Product Change Notification (PCN)

PCN Number	510048	Date Issued	March 19, 2021
Reason for Change	Change to Product		
Change Type Description	This letter is to inform you that changes are being made to the part(s) identified in this Notice. The change may affect the fit, form, function or appearance of the parts, or it may result in a change to the specification. The pictures below show an example of the possible differences.		
Reason for Short Notice	Corrective Actions		
Assessment of Change	No change to parts/components FFF		
Internal Molex Qualification Date	March 19, 2021		
Sample Availability Date (Changed Part)	March 19, 2021		
Planned Implementation Date	April 30, 2021		
Method of Identifying Change	No special marking on the product or packaging

- We found there are some typo on 5054330003-SD. We notify about correcting the following misdescription on the drawing.
There is no change to the product itself, so there is no impact to Form, Fit or Function.
- Objective Drawing number: 5054330003-SD PSD 000
 - Current Revision: Rev. A
 - After Revision: Rev. B
- Change point on the drawing

Change Point : Plating information and Part number

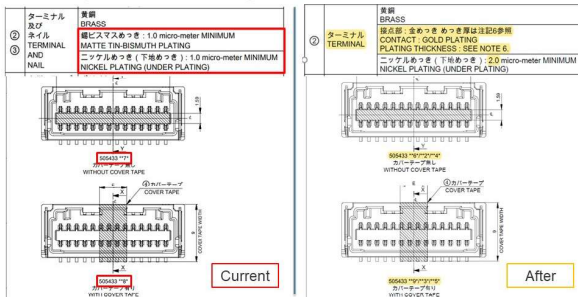
Change point	Current description	After description
Plating of Terminal	MATTE TIN-BISMUTH PLATING	GOLD PLATING
Under Plating of Terminal	1.0 micro-meter MINIMUM	2.0 micro-meter MINIMUM
Part Number	505433 **7*, 505433 **8*	505433 **6*, 505433 **2*, 505433 **4*, 505433 **9*, 505433 **3*, 505433 **5*,
